## ADDENDUM

**ADDENDUM NO.:** 01  
**PROJECT NAME:** CIP Central Hearing Facility Roof and MEP Upgrades  
**PROJECT NO.:** 04044  
**CONTRACT NO.:** C1606  
**DATE OF ISSUE:** December 21, 2023

### NOTICE OF CHANGES, MODIFICATIONS, OR CLARIFICATIONS TO CONTRACT DOCUMENTS

PBC Project Name: CIP - Central Hearing Facility Roof and MEP Upgrades  
 PBC Contract No: C1606  
 Project No.: 04044  
 Title: FIFTH FLOOR REFLECTED CEILING DEMO & NEW WORK PLAN  
 Sheet: AC-105

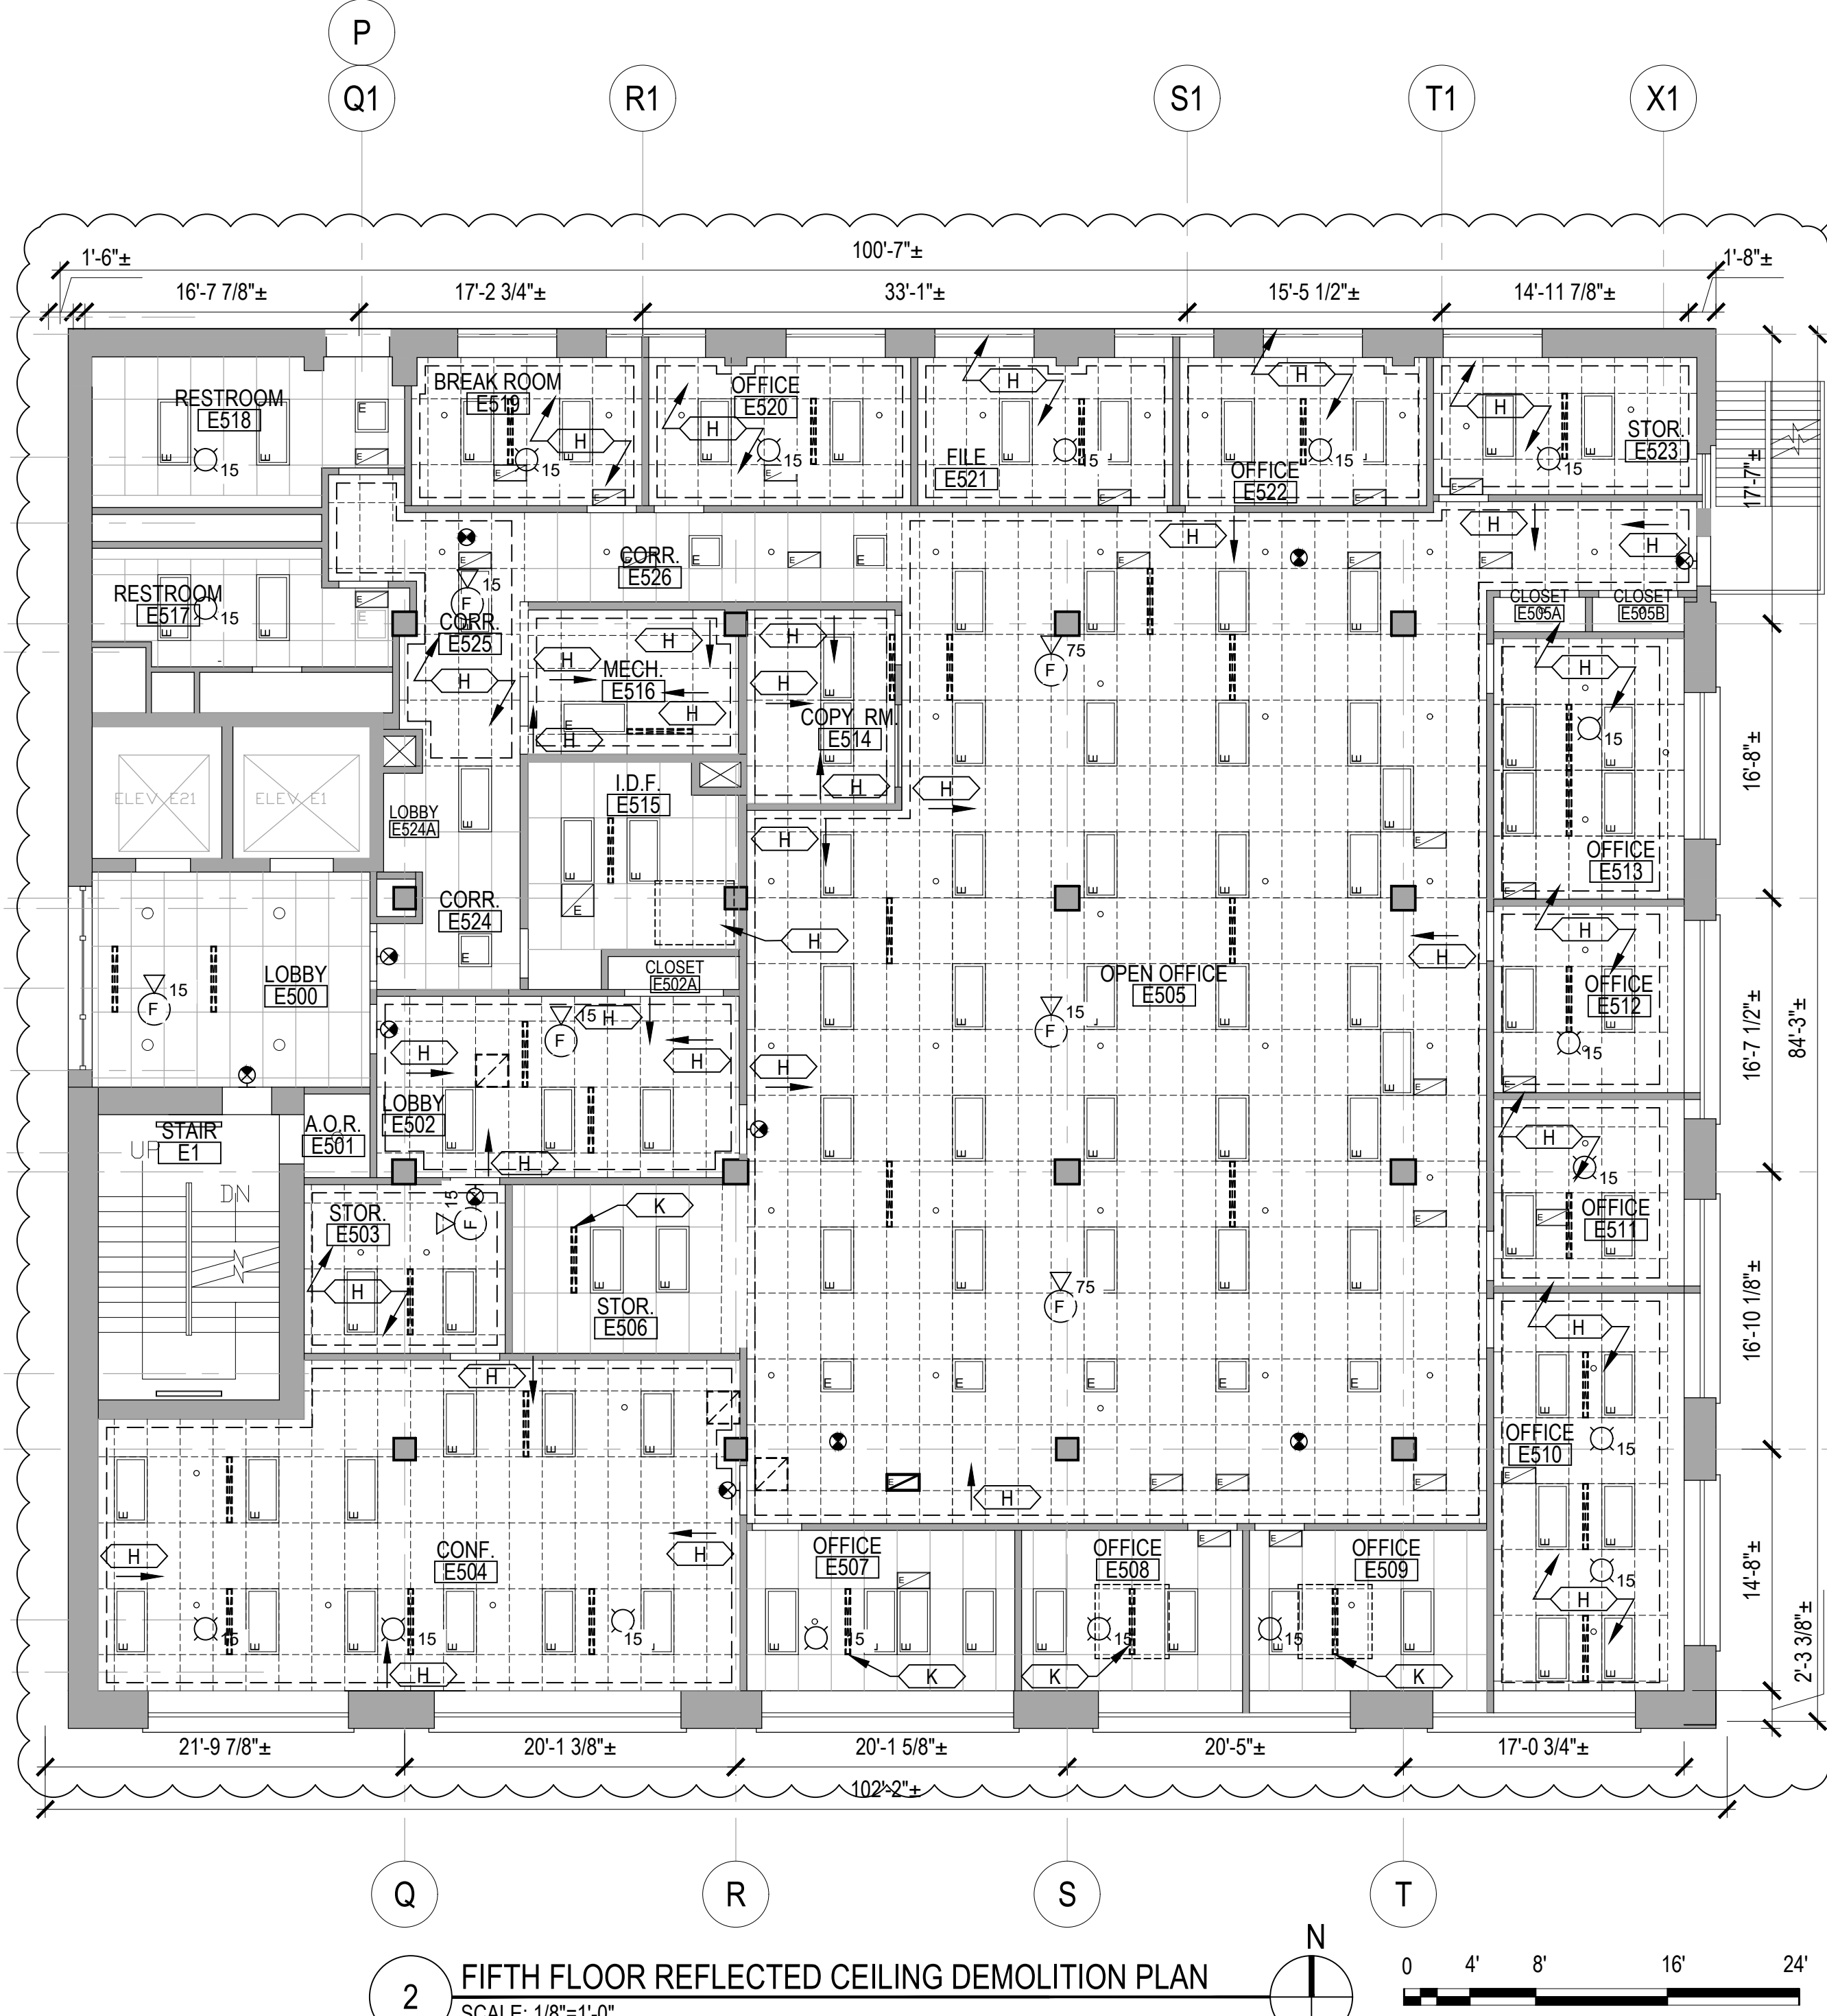
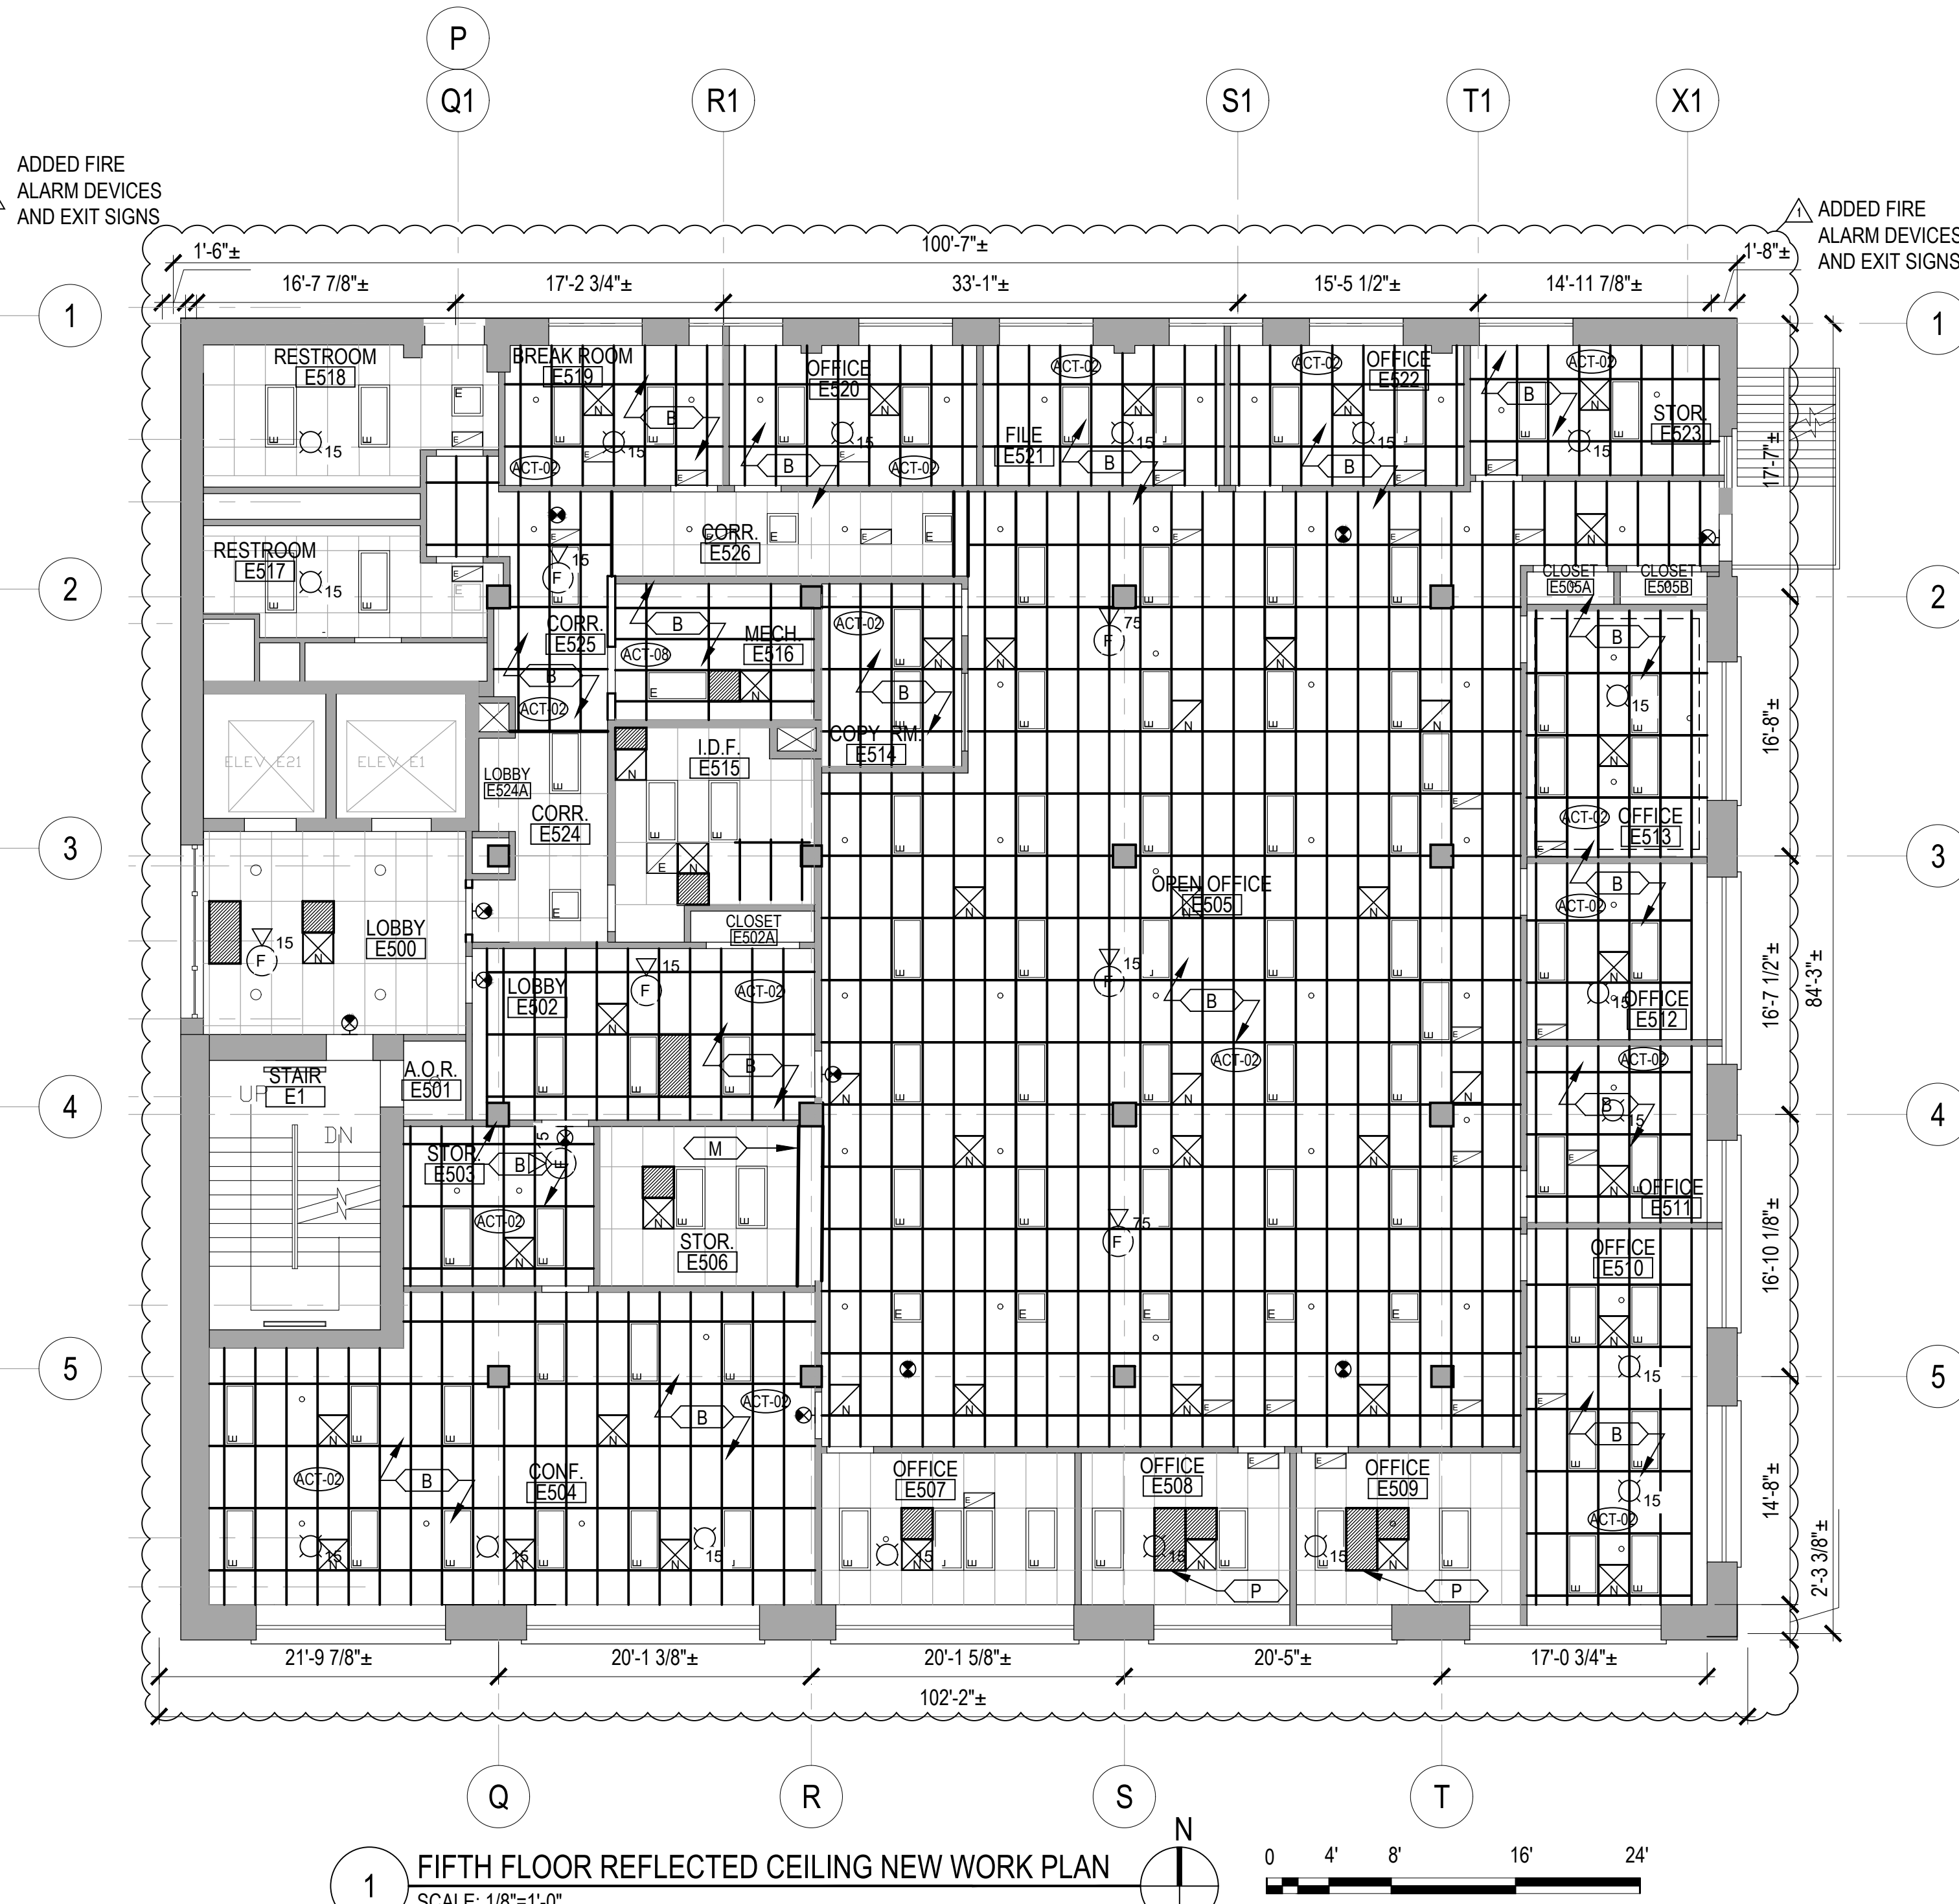
**Change 13** Drawing No. AC-105 –**REVISED** sheet to add existing ceiling hung devices, dated 12.21.23  
**Change 14** Drawing No. AC-106 –**REVISED** sheet to add existing ceiling hung devices, dated 12.21.23

**Response:** [Ceiling plans have been revised to identify the ceiling-mounted exit signs and fire alarm devices. Please refer to architectural drawings included in this addendum.](#)

Sheet  
**MD-104**

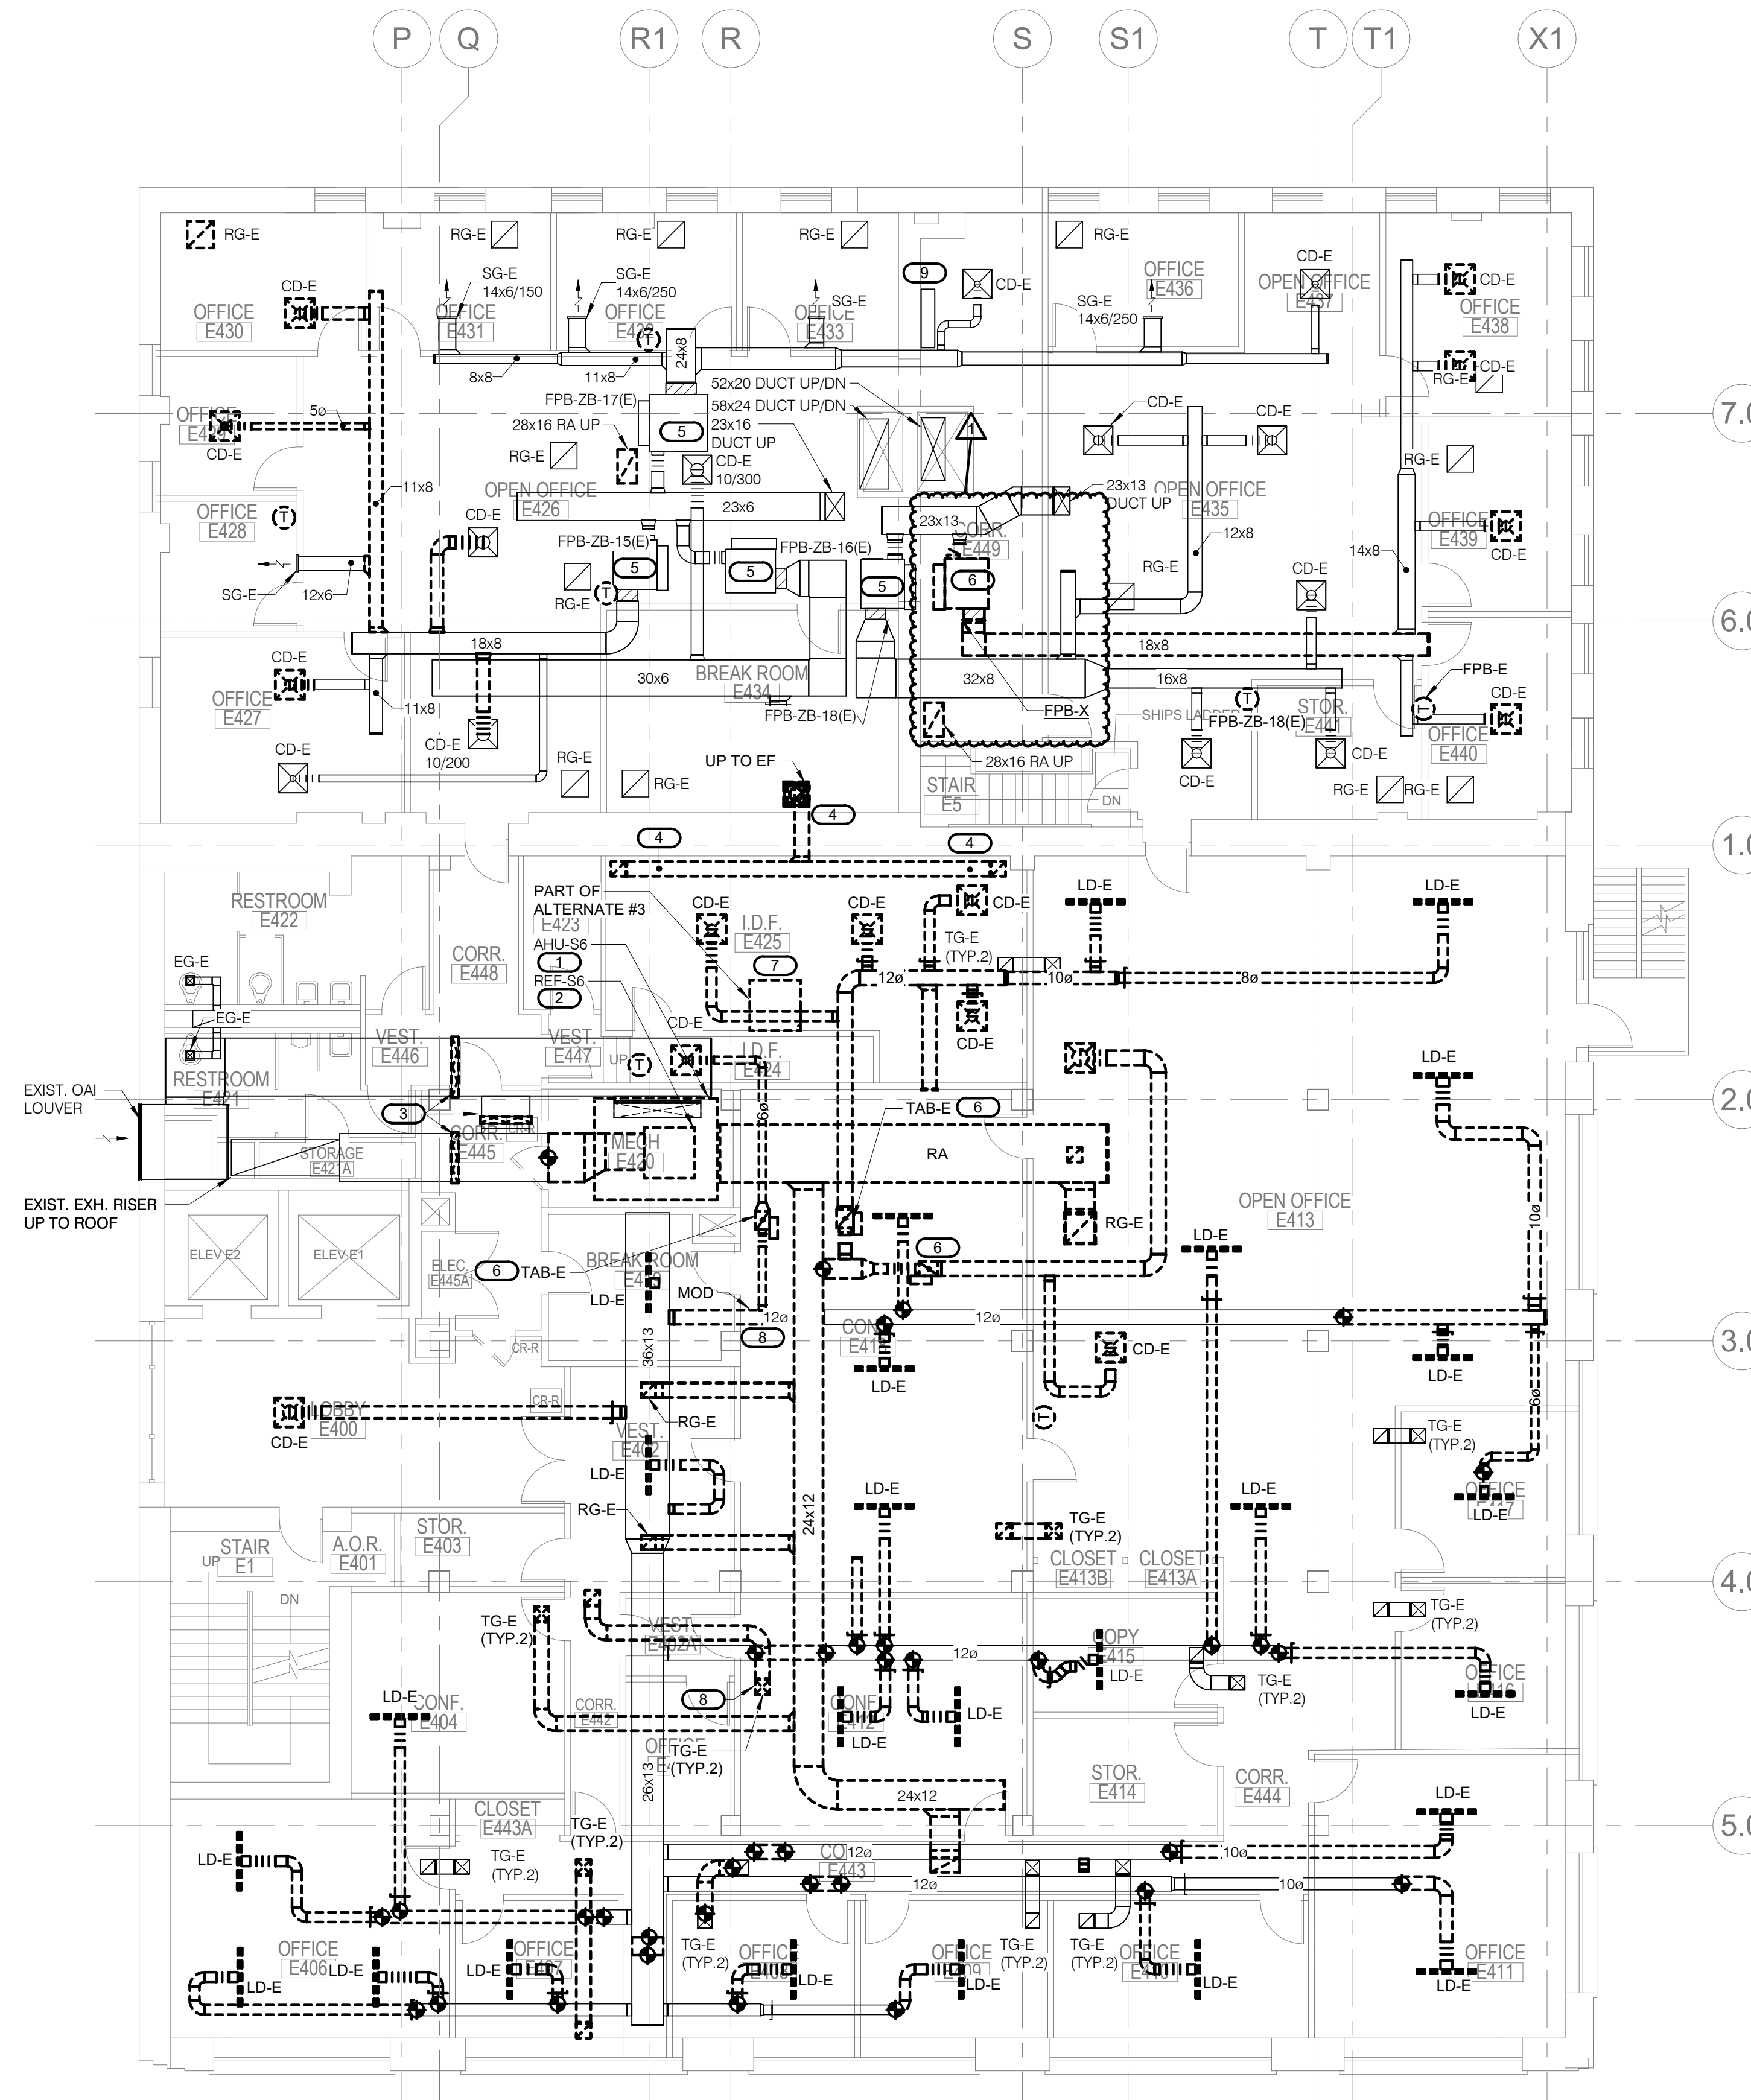
**Change 15** Drawing No. MD-104 – **REVISED** sheet to reflect updates above Room E449, dated 12.21.23  
**Change 16** Drawings No. E-102E-**REVISED** sheet to add VFD, Dated 12.21.23
